Brisbane Flooding January 2011

An Avoidable Disaster – Supplementary
Submission 2

9 June 2011

Figure 1

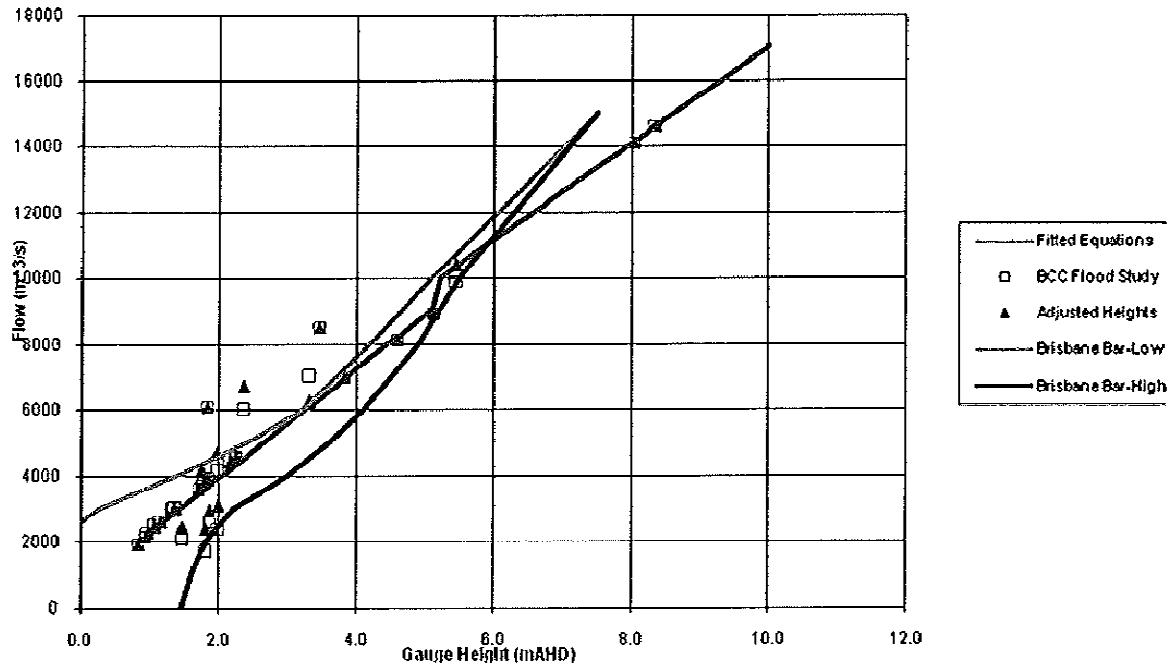
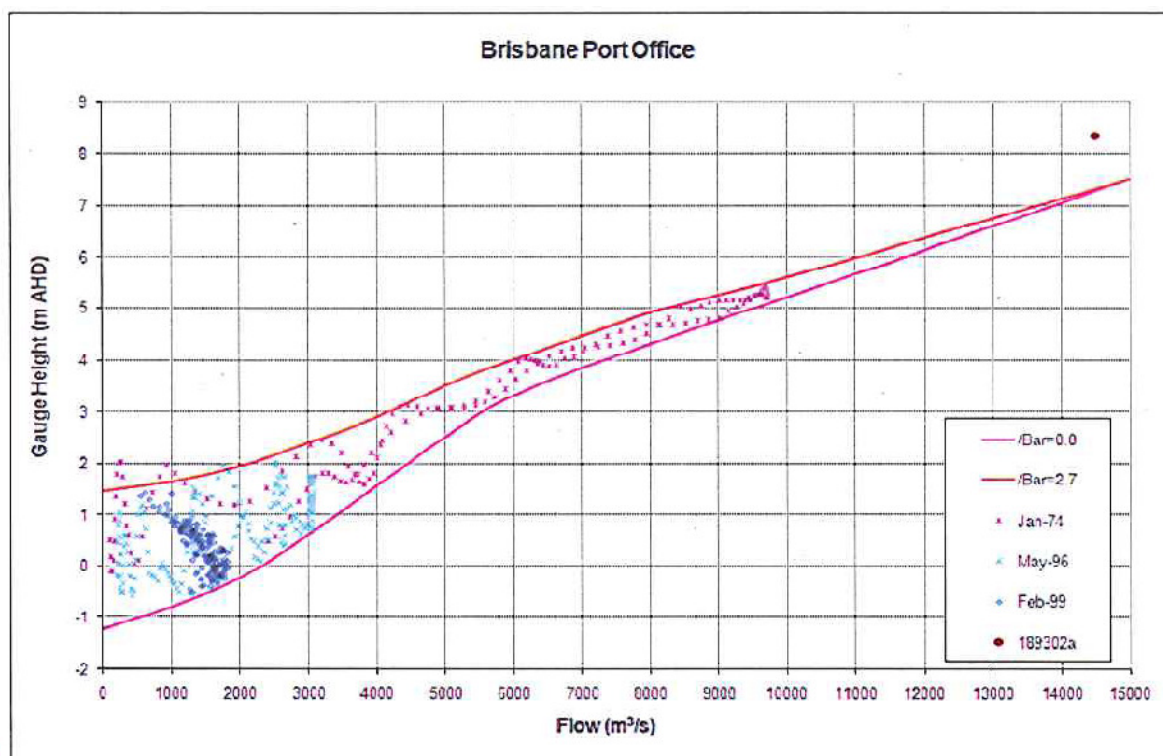
These graphs appear to provide the same data but are plotted differently. The first graph (provided in Exhibit 20) merely indicates that the rating curves are for the Brisbane Bar at Low Tide and the Brisbane Bar at High Tide, but includes no information in relation to the actual tide heights. However at paragraph 32 Robert Ayre indicates that "*These relationships are based on numerical hydraulic models of low tide and high tide at the Brisbane Bar (0.0mAHD and 2.7mAHD respectively).*"

The second graph included in the Statement of Terrence Alwyn Malone indicates that the curves are for "*Bar=0.0 and Bar=2.7*".

Tide heights at the Brisbane Bar are not generally reported in mAHD, but instead are referenced to a Prediction Datum which is 1.24 metres lower than 0.00 mAHD. A tide of 2.7 m at the Brisbane Bar is close to the Highest Astronomical Tide and therefore a tide of 2.7 mAHD at the Brisbane Bar would represent a tide of 1.24 metres above the Highest Astronomical Tide which is an unlikely reference point.

It is therefore suspected that the 0.0 mAHD and 2.7 mAHD used by Robert Ayre should instead be tide heights in metres referenced to the Brisbane Bar datum and not mAHD. This would mean that the first graph is then fully consistent with the second graph included in the Statement of Terrence Alwyn Malone. Both rating curves would therefore be for 0.0 m to 2.7 m at the Brisbane Bar or minus 1.24 mAHD to 1.46 mAHD.

In the response to the Original Submission (7) Robert Ayre raised a number of concerns about this rating curve. However the first graph above, which includes a plot of this rating curve, demonstrates that the developed rating curve used in the Original Submission adequately matches one of SEQWater's preferred curves over the range of interest for these submissions. This range of interest is from the level of a Minor Flood at the Brisbane City Gauge which is 1.7 mAHD through to the peak experienced during the Flood Event of 4.46 mAHD.

Again referring the rating curves provided by SEQWater and referenced in Section 4.1 above a flow of 9300 m³/sec would be expected to result in the following heights at the Brisbane City Gauge: -

- Utilising the first graph between 4.66 mAHD and 5.2 mAHD for a tide height at the Brisbane Bar of 0.0 m and 2.7 m respectively.
- Utilising the second graph, between 4.43 mAHD and 5.0 mAHD for a tide height at the Brisbane Bar of 0.0 m and 2.7 m respectively.

This range depends on the tide height at the Brisbane Bar of 0.0 m or 2.7 m respectively (or minus 1.24 mAHD to 1.46 mAHD). Given that a high tide of 0.91 mAHD was recorded at Whyte Island at 03:06 Thursday 13th January, a flow of 9,300 m³/sec would be expected to result in a height at the Brisbane City Gauge at towards the upper end of the above ranges of 4.43 mAHD to 5.2 mAHD. This is not the case and the hydrologic model instead provides an estimated height of 4.46 mAHD, very close to the lowest possible estimate.
